ADDENDUM NO. 3

May 3, 2022

YOST ELEMENTARY SCHOOL ADDITIONS AND RENOVATIONS
Chesterton, IN 46304

Addendum Three (AD.03) to the drawings and specifications prepared by Gibraltar Design for **New Newton Yost Elementary School** for Duneland School Corporation, Chesterton, Indiana.

UNIT "A" ARCHITECTURAL FIRST FLOOR PLAN

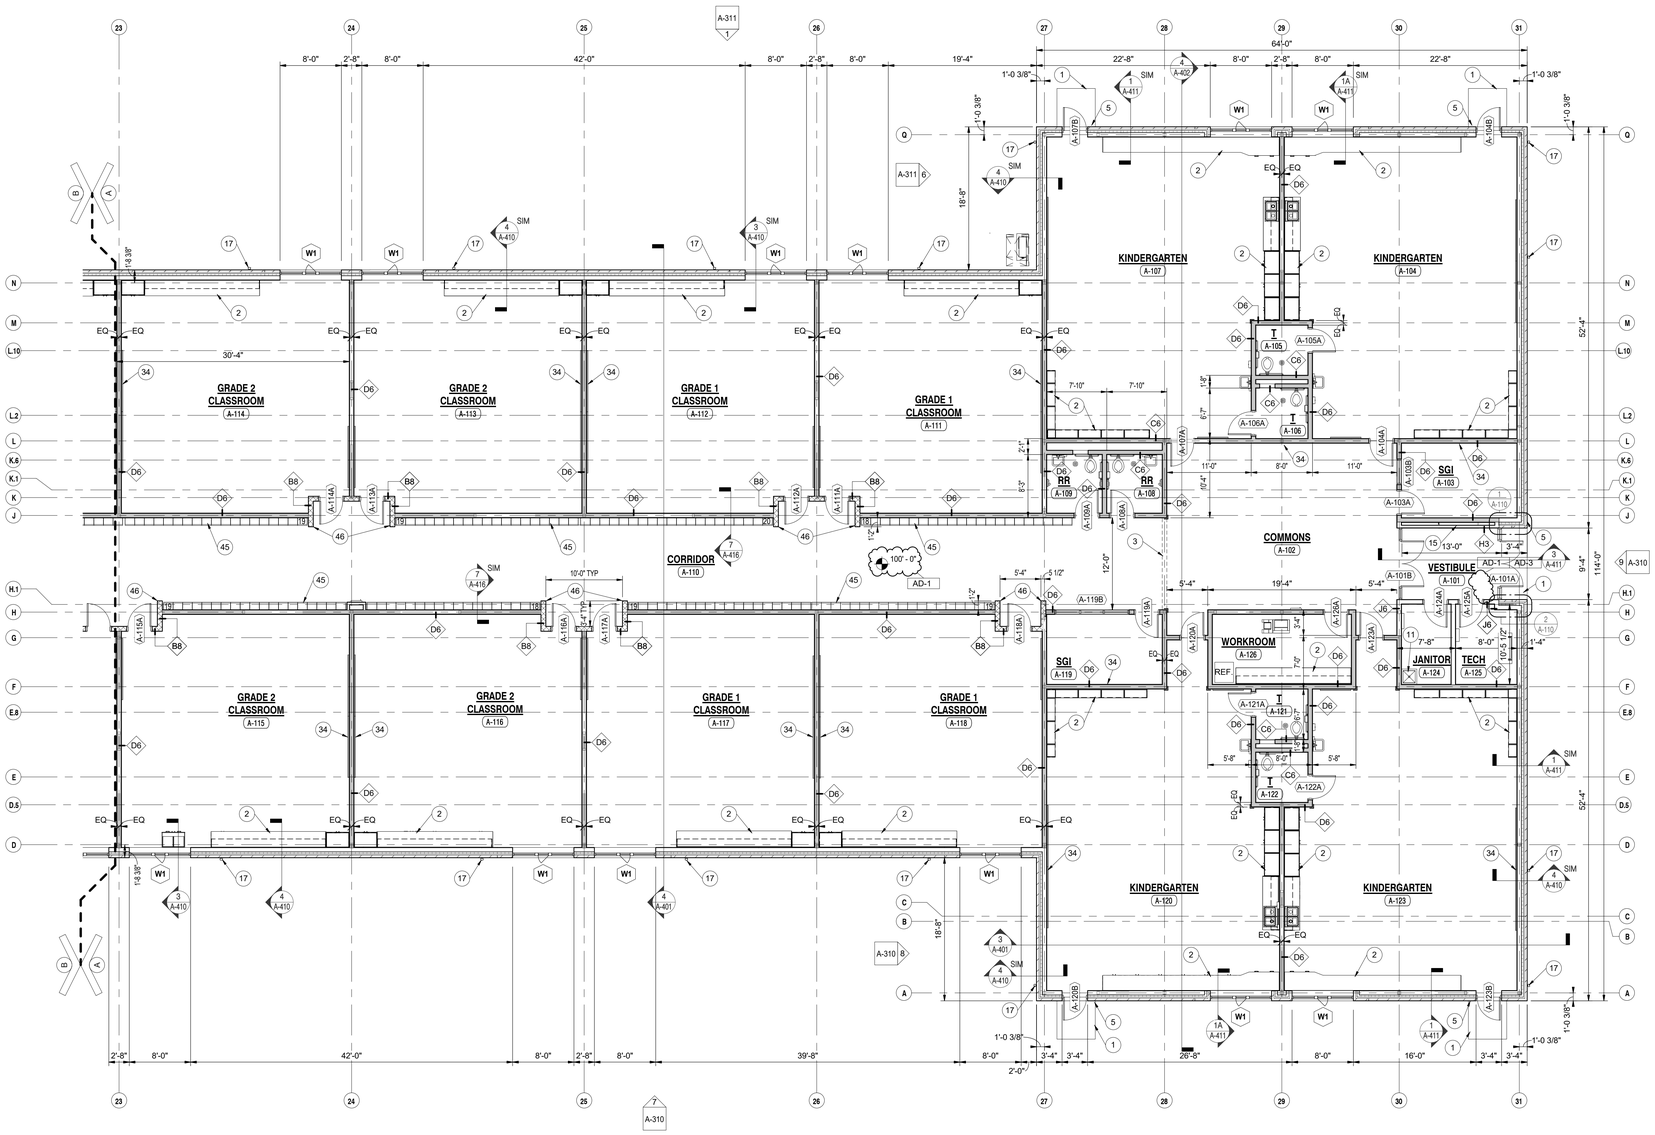
52. Sheet A-101

UNIT "B" ARCHITECTURAL FIRST FLOOR PLAN

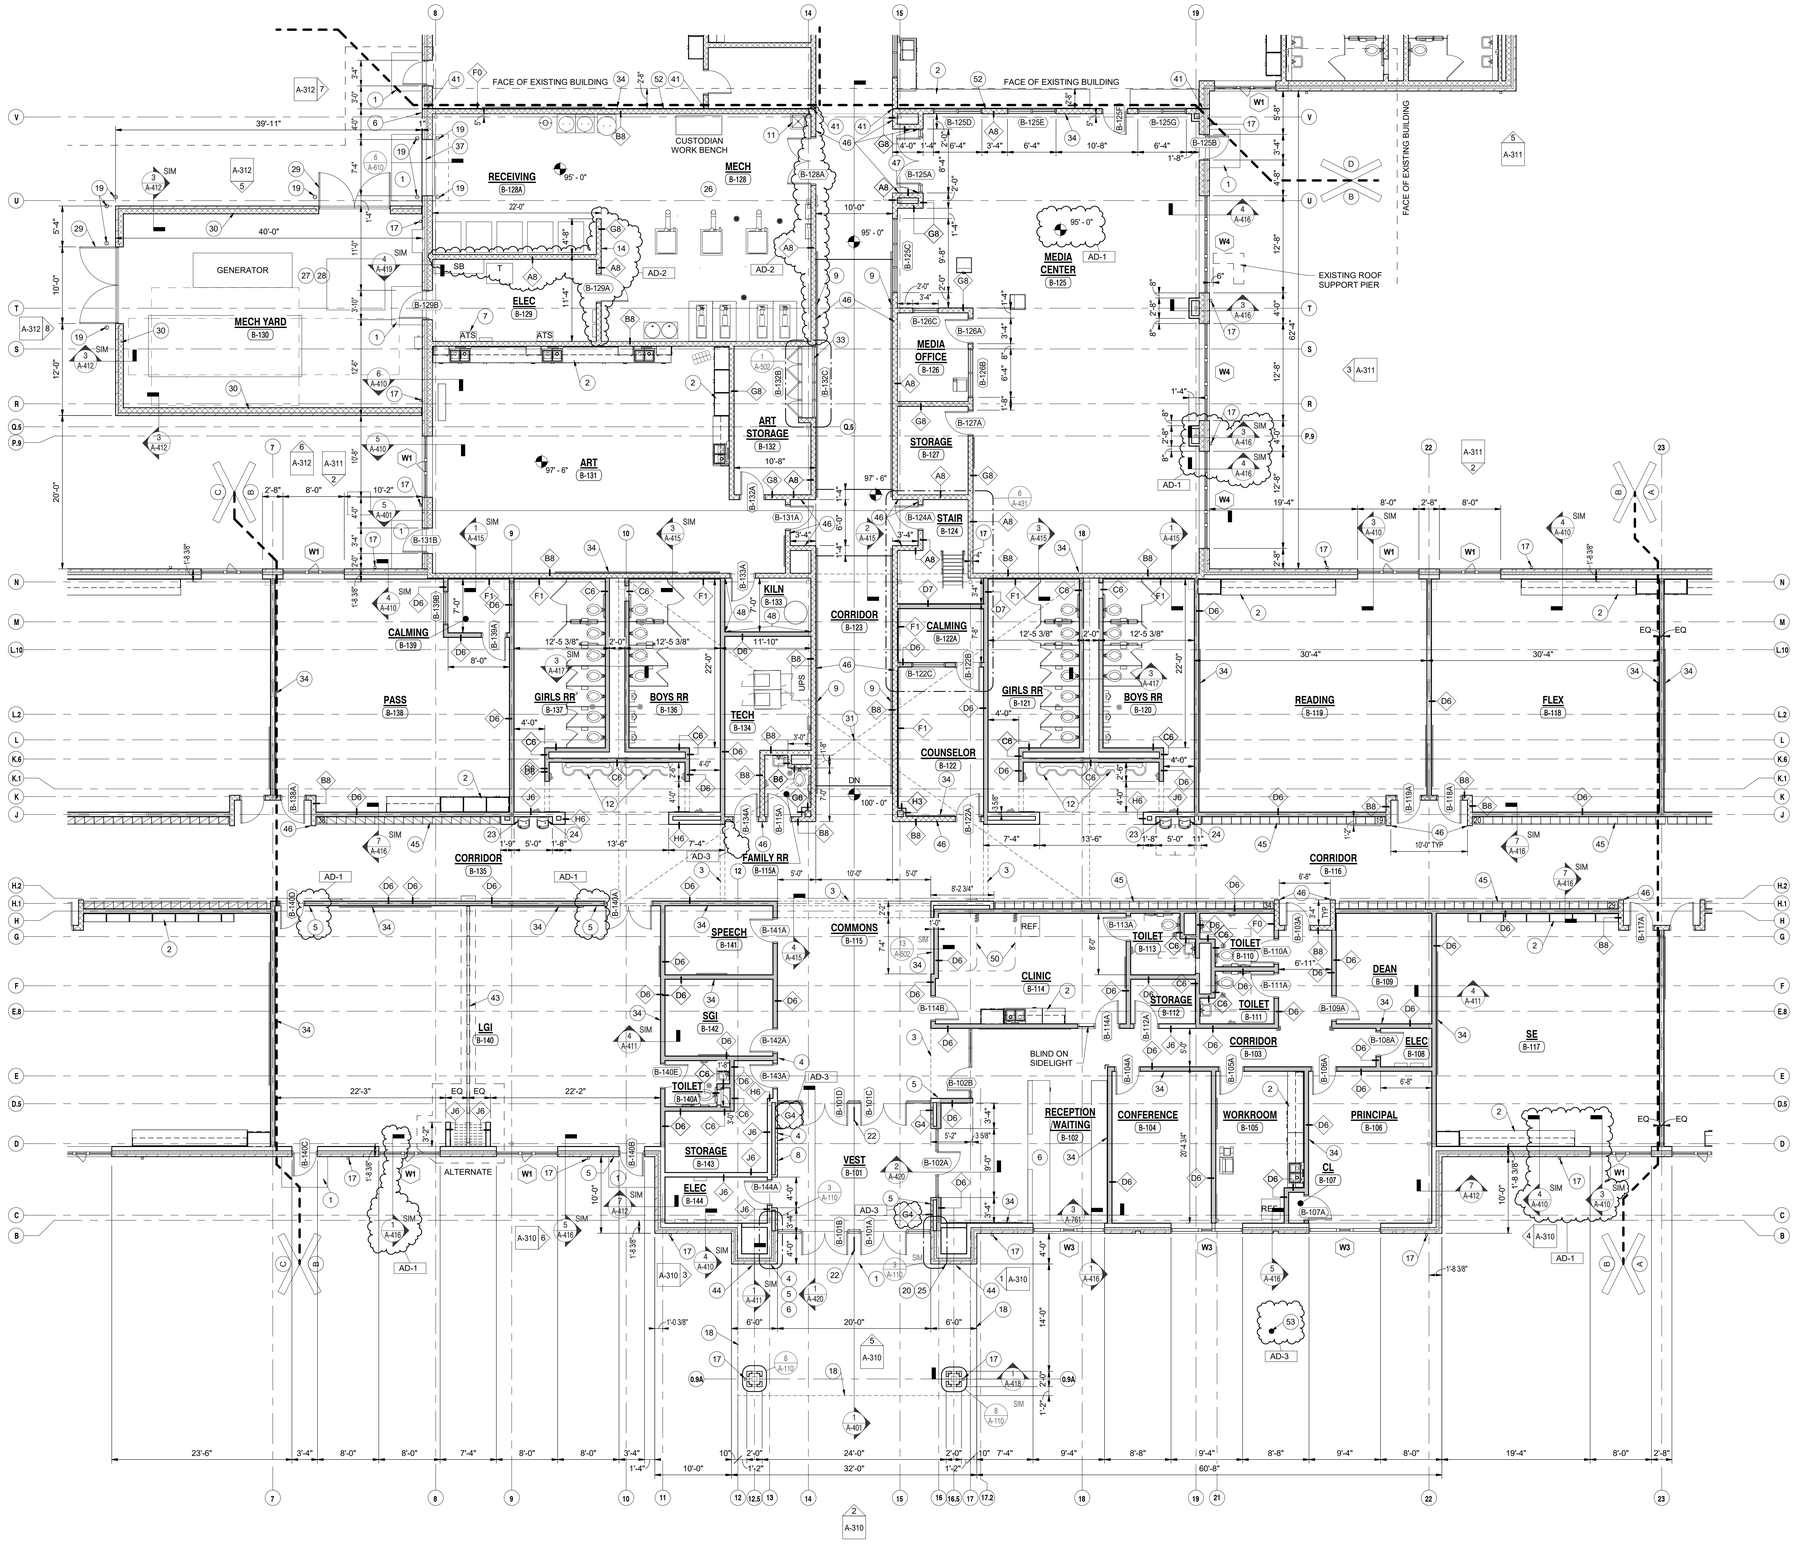
53. Sheet A-102

1 A-103 UNIT "C" ARCHITECTURAL FIRST FLOOR PLAN

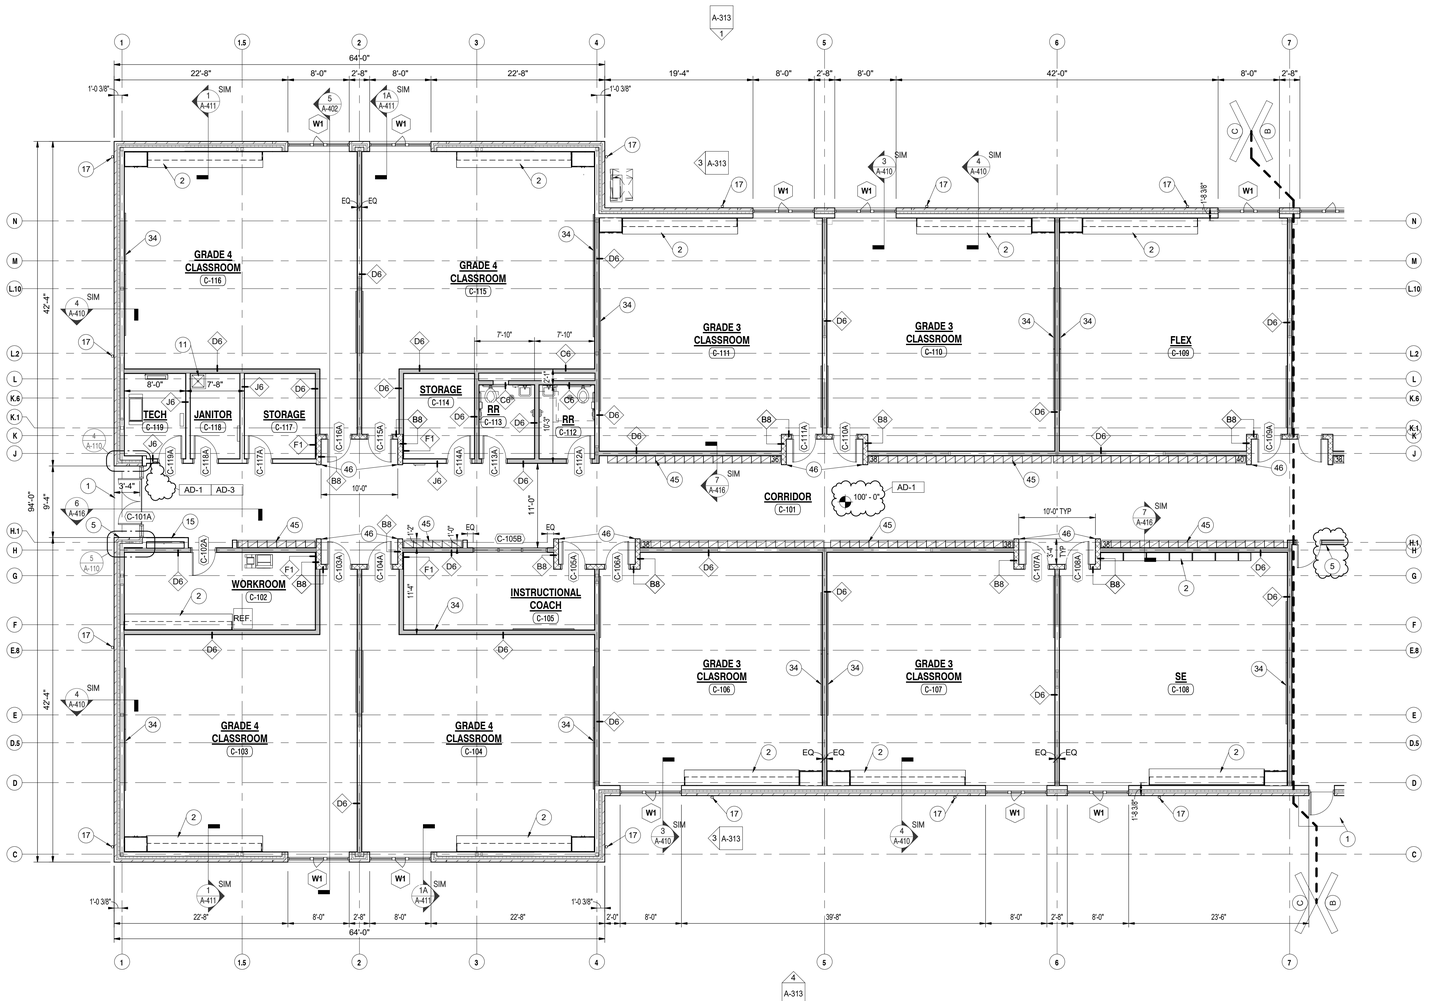
54. Sheet A-103

1 A-105 **UNIT "E" ARCHITECTURAL FIRST FLOOR PLAN**
1/8" = 1'-0"

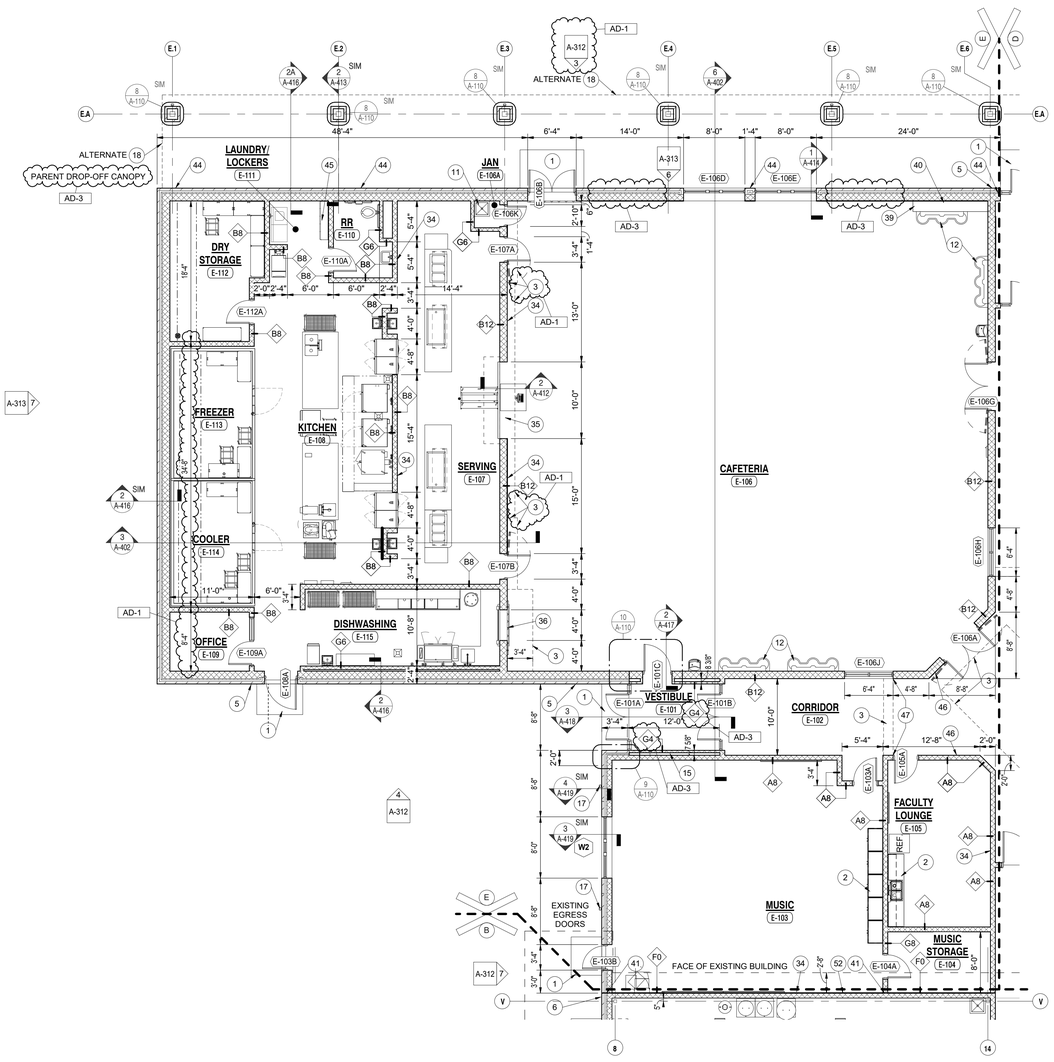
56. Sheet A-105

1 A-201 **OVERALL ROOF PLAN**
1/16" = 1'-0"

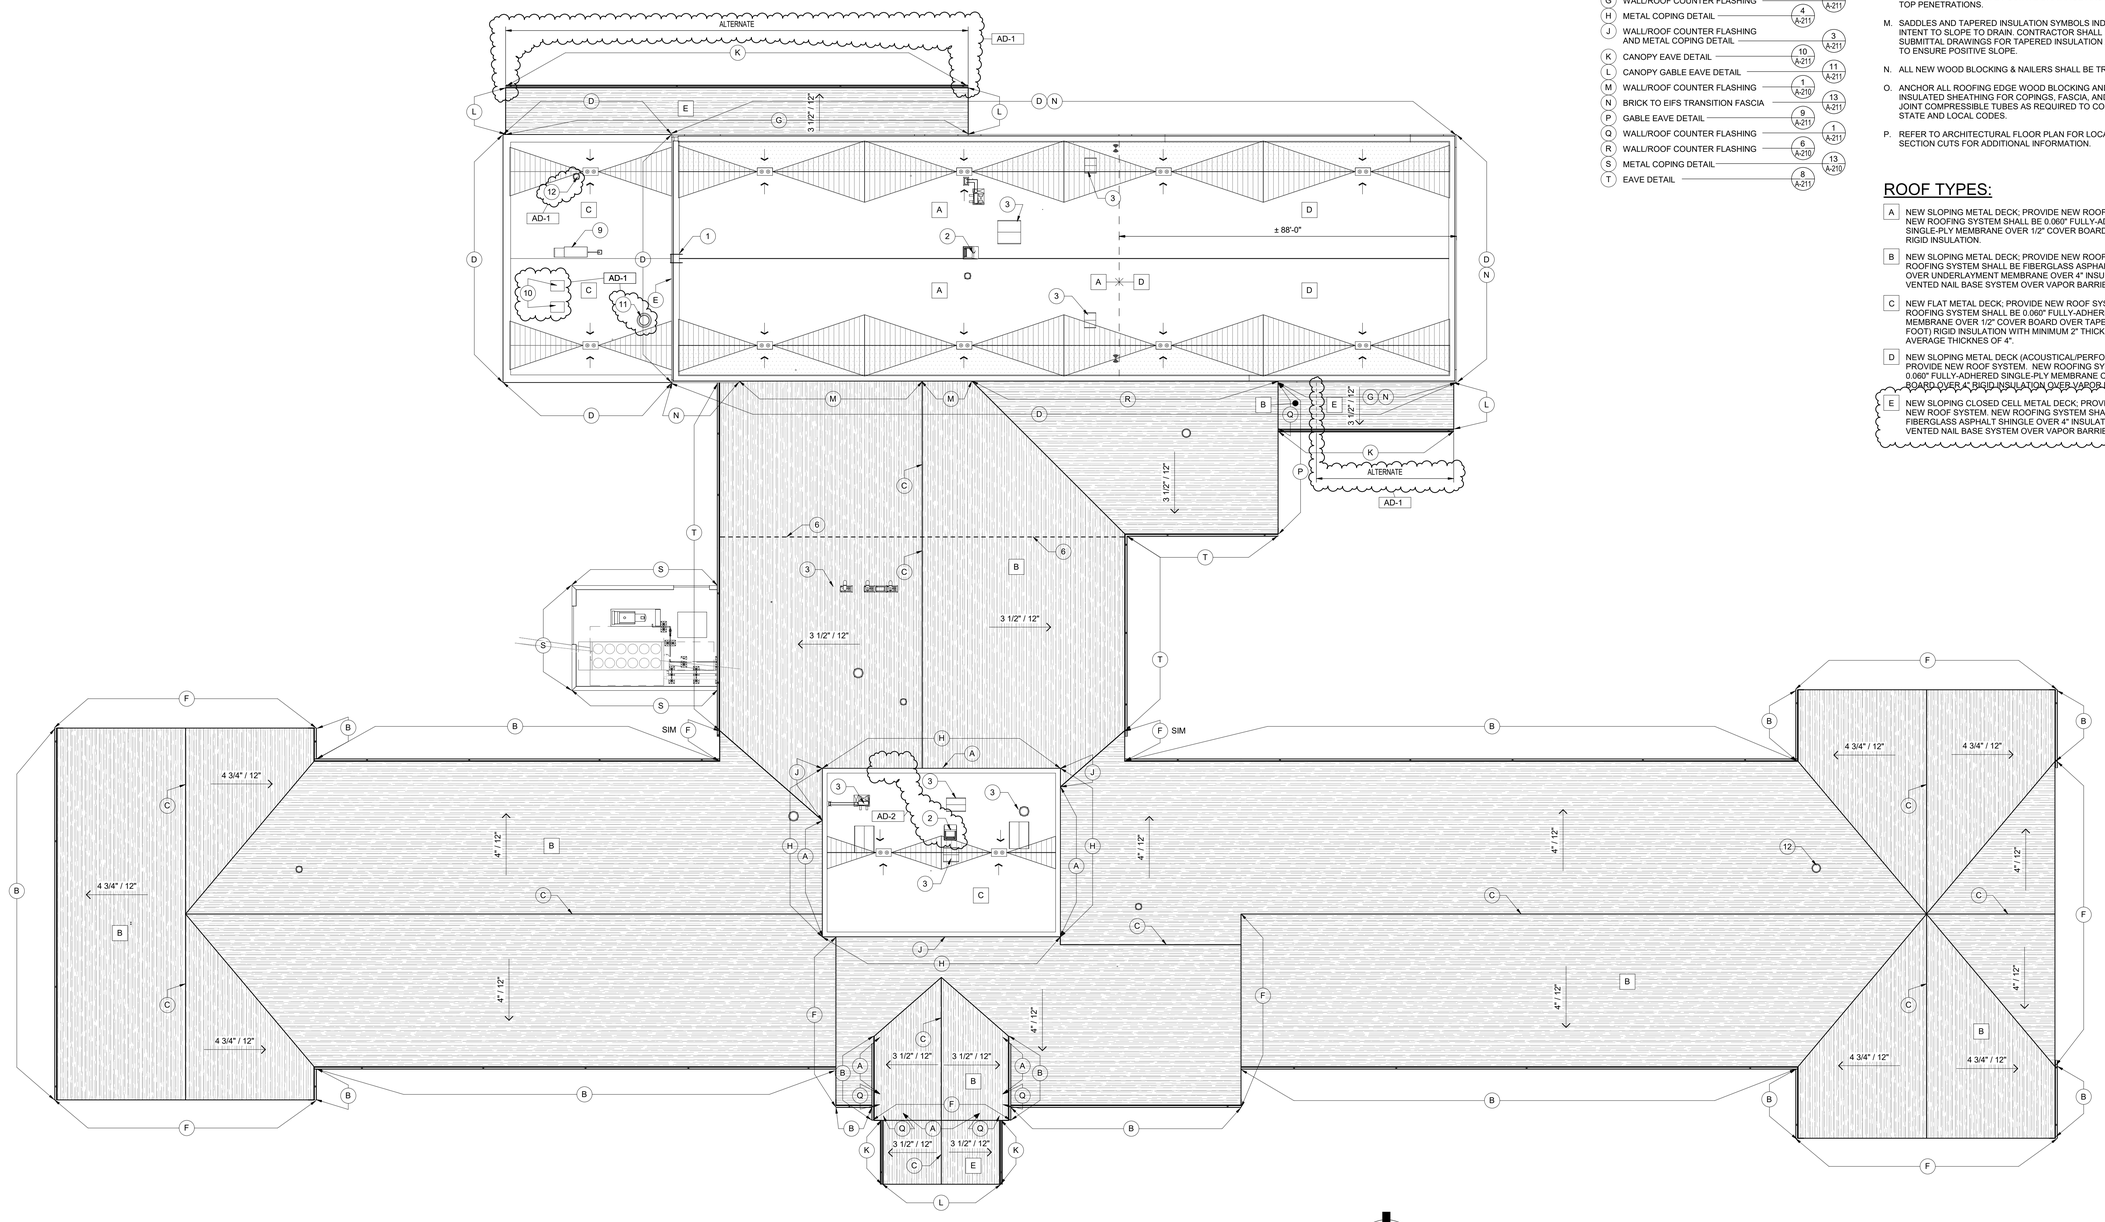
57. Sheet A-201
